# Product Change Notification

PCN #: 10C-2018

DATE: October 30<sup>th</sup> 2018

- Base/battery cover changes – applied to all variants

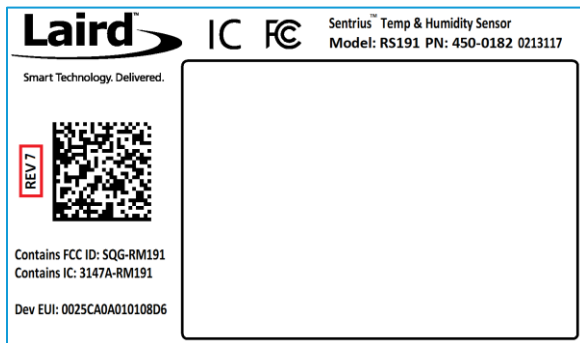
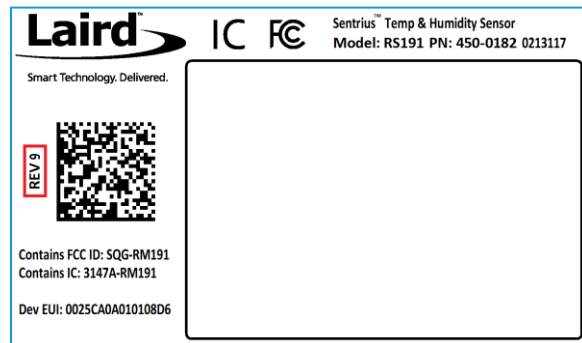
Rev 1,2 – 2 screws

Current Rev 9 – 4 screws

Changes to 450-0182 and 450-0183			
Rev		Rev	Description
7	to	8	Added screw stay washers for the battery cover screws.
8	to	9	New firmware that includes bug fixes and feature enhancements. See firmware release notes for specifics.

- Usability improvements when unscrewing the battery door.
- Functional improvements with firmware.

- Labelling Changes – 450-0182

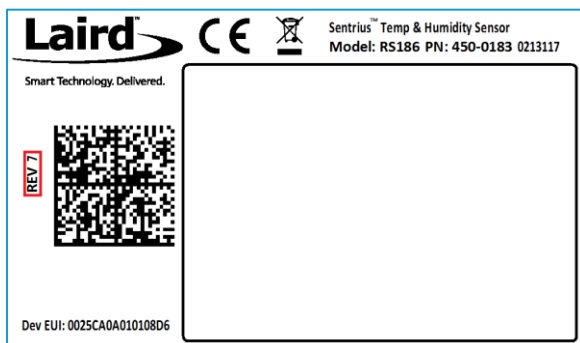
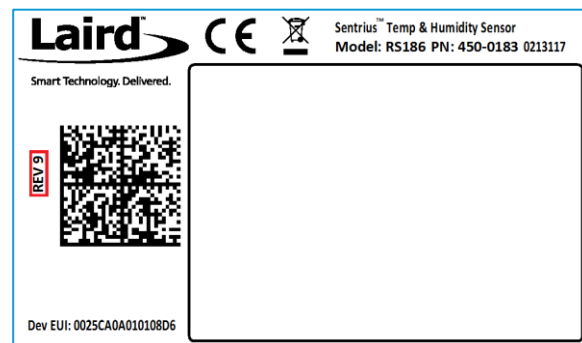
Rev 7

Current Rev 9
